Subject: NRC Staff Position Regarding Detection of Linear Indication
on the Multi-Vane Diffuser Shroud in Safety Injection Pumps
Installed in Comanche Peak Steam Electric Station (Units 1 and 2)

Texas Utilities Company
Comanche Peak Units 1 and 2
Docket Nos. 50-445/446

I. INTRODUCTION

FIGURE 1

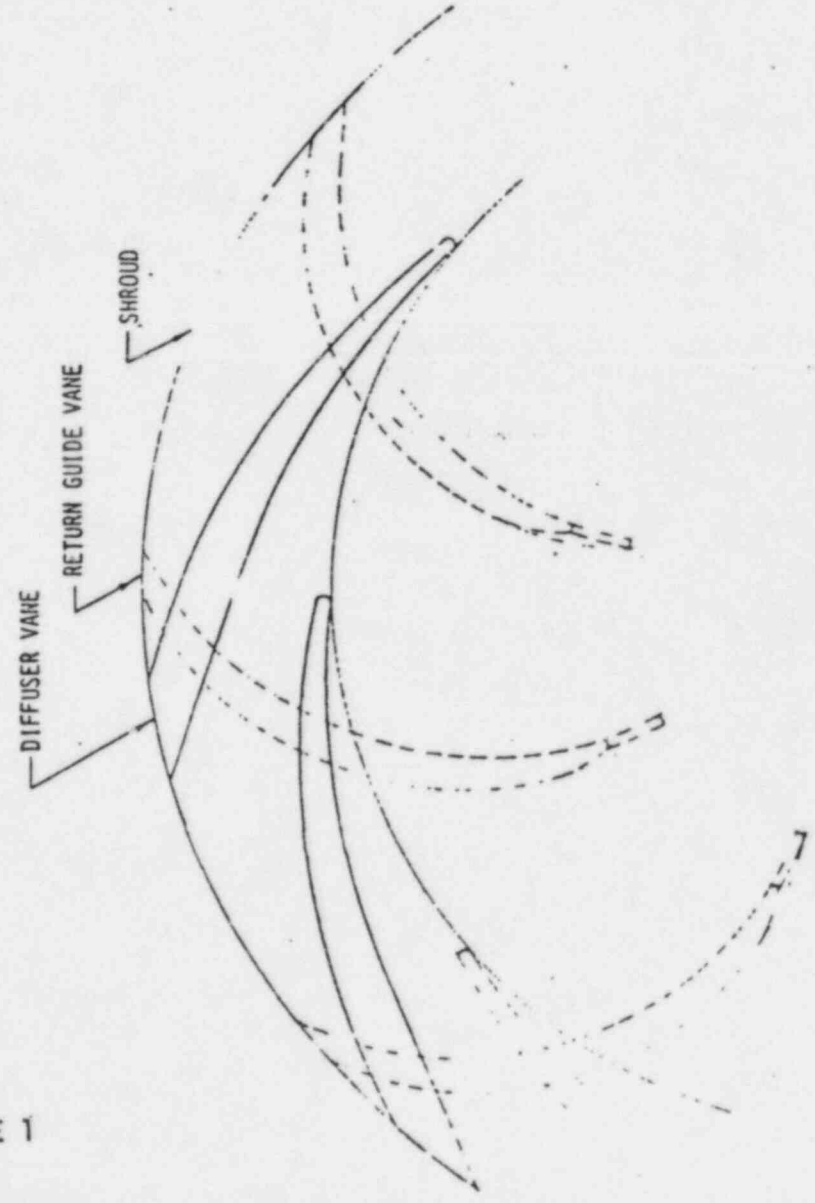
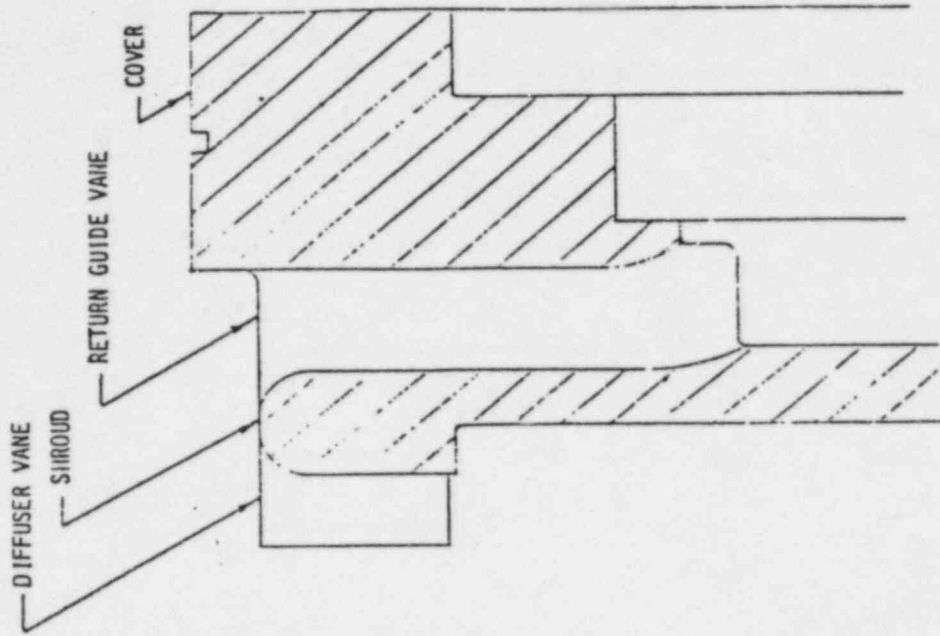
The stresses carried by the pump intermediate cover (see Figure 1) were analyzed by the finite element method to show the generally low stress condition in the area of indication and to provide data for use in a fracture mechanic analysis. The cover shown in Figure 1 is one of a number of static members assembled at the same time as the impellers and alternate with the impellers. Each cover serves to guide the water from the outlet of a previous impeller to the inlet of a subsequent impeller where the water is pumped to a higher pressure. As a result each "cover"

For the actual analysis, the equivalent pressure load was applied to the cover end of the part with the diffuser vane end fixed in the axial direction. Three models were run to determine if any significant redistribution of local stresses occur due to the presence of the indication in the part. The indication was simulated by removing thin elements to create a notch-type void in two of the models. The third model includes the complete section. The finite element analysis showed that the stress distribution in the shroud is mostly due to a bending load acting across the section. This agrees with expected behavior since the load path is predominantly from the return vane to the diffuser vane and is introduced into the shroud as bending from the forces applied by adjacent vanes. In addition, the analysis shows that the absence or presence of the indication does not significantly alter the stresses. The magnitude of the stresses are quite small especially when

FIGURE 2. Predicted number of on-line fatigue cycles required to extend a radially oriented edge crack to 1-inch in length. Initial size or depth of hot tear is indicated on horizontal axis.

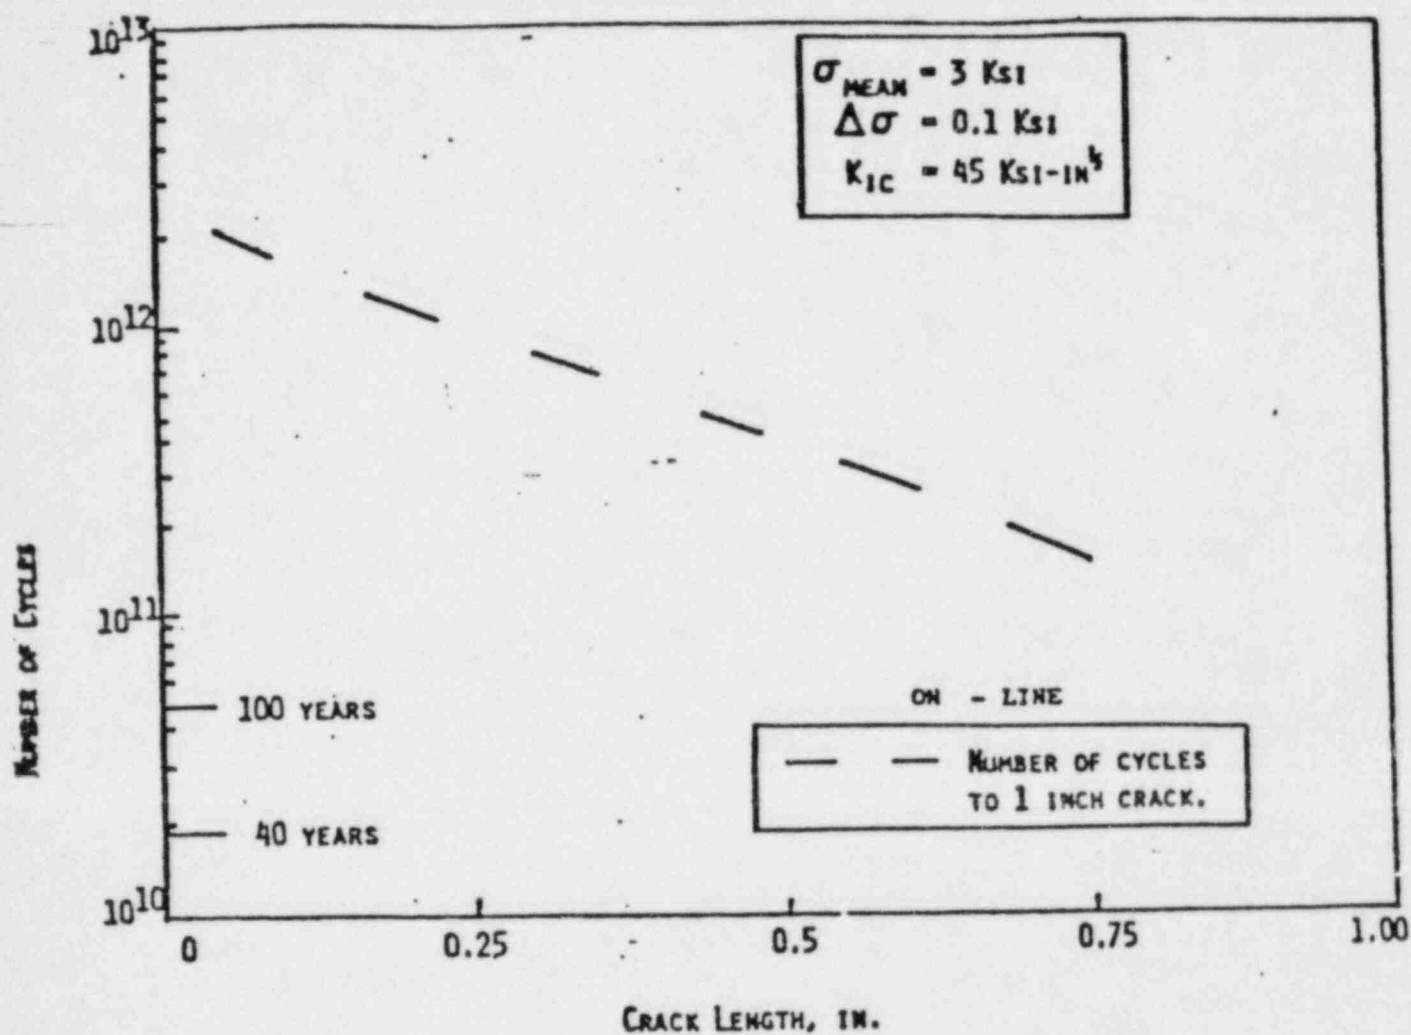
and calculating the number of cycles for a hot-tear to extend to 1-inch, the number of cycles to extend the hot tear to 1.0 in. is shown on Figure 2. As noted, over 100 yrs of projected on-line pressure pulses would be required. Similarly, over 40,000 years of projected start-up cycles would be required to extend the hot tear to 1.0 in. radial length.

FIGURE 3. Safe-life design envelope for a projected 20,000 million cycles of on-line pressure pulses. Circle indicates actual operating conditions.

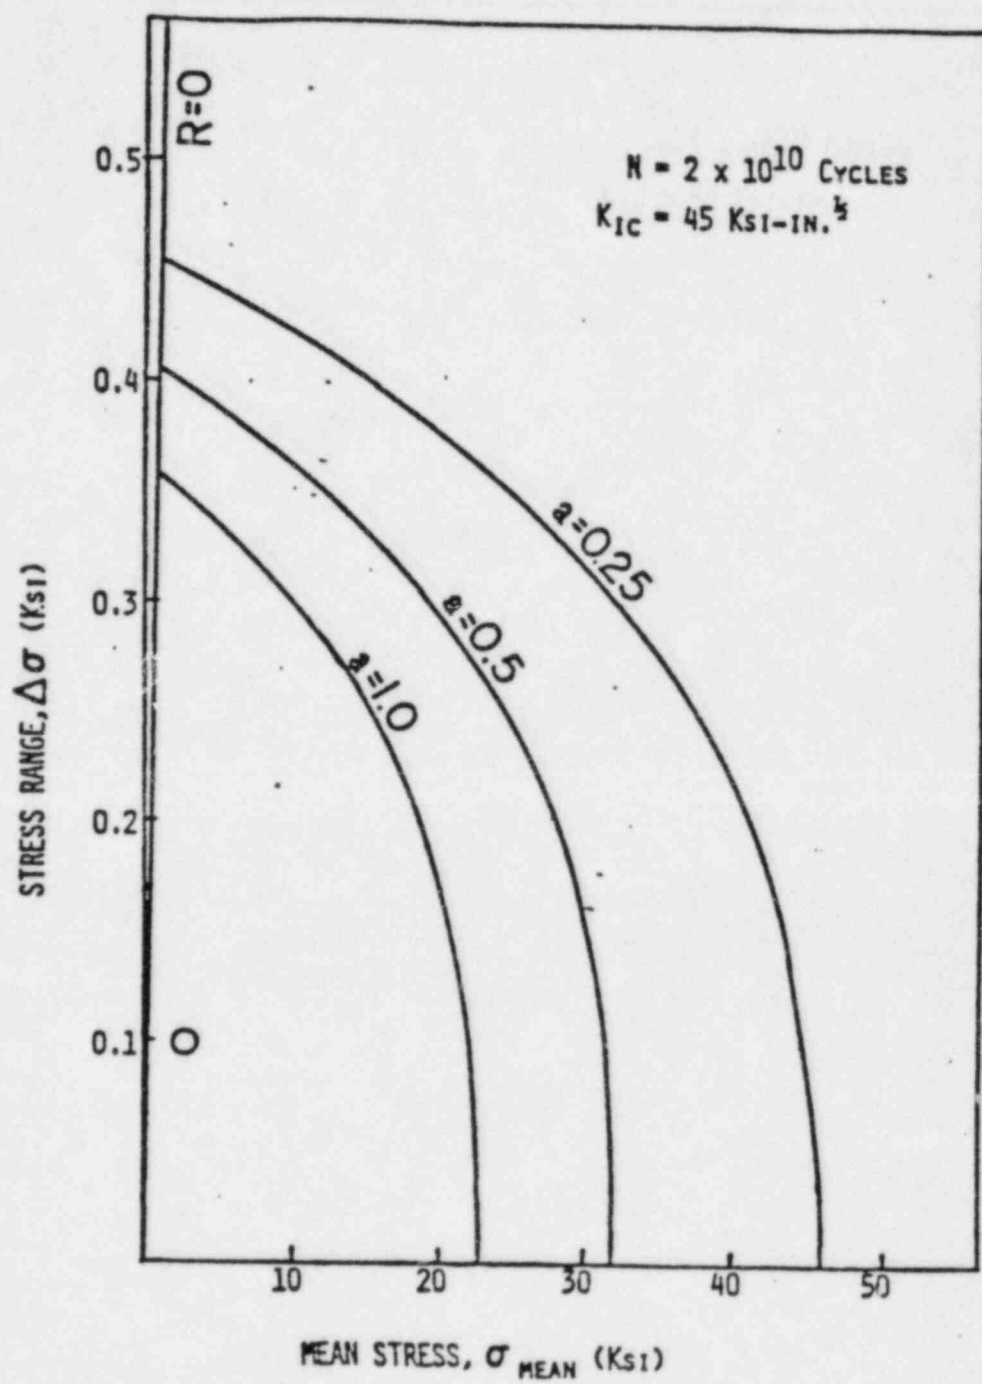
The stress range $\Delta\sigma$ and σ mean can be delineated as shown in the fracture mechanics modified Goodman diagrams of Figures 3 and 4.

As observed on studying Figures 3 and 4, the operational stresses are far below any combination of mean and alternating stress range that would exceed the safe-life zone delineated by the lines for $a_0 = 0.25, 0.50,$ or 1.0 in. Obviously these zones decrease in size as the assumed initial size of the hot tear increases.
